URGENT RECALL NOTICE

Subject: Product Safety Issues

Affected Products: OEC® UroView 2800 and OEC® UroView 2800 with Dual Monitor Option

Figure #1 – Mount Monitors as shown in Back View of System

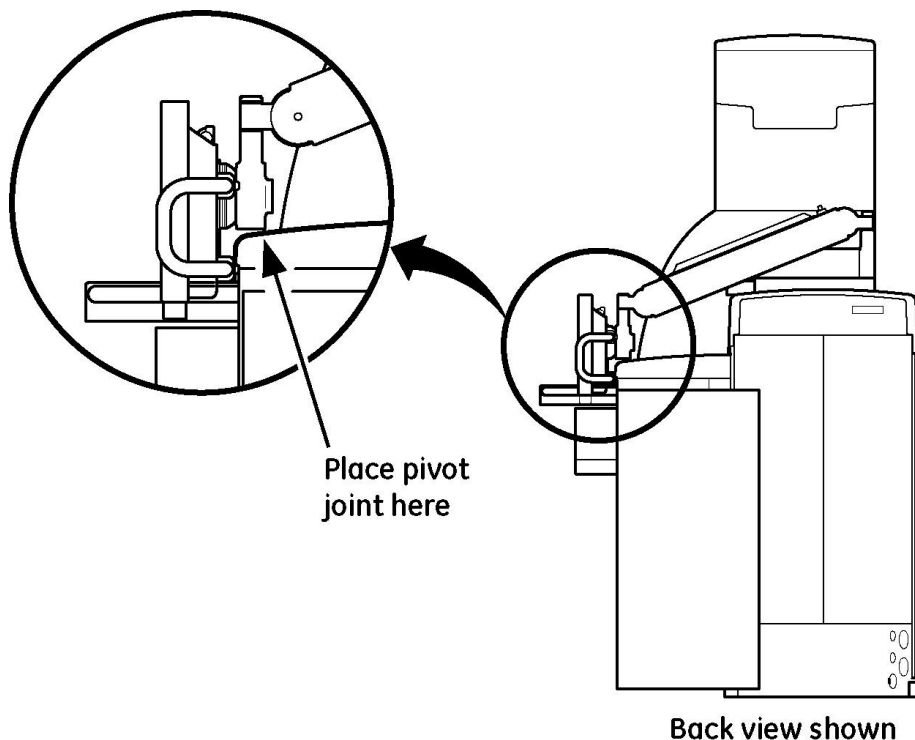
- Position the dual monitors so that they rest on top of the tower as shown in Figure #1 (Please be advised that this should be done carefully or you could scratch the surface of the generator housing.)
- Attach the WARNING Tag (Example of Tag in Figure #2) to the left or right dual monitor handles as shown in Figure #3 with the supplied Cable Tie. (Please note that the tag should be placed in such a manner that the WARNING Tag is clearly visible to any user)
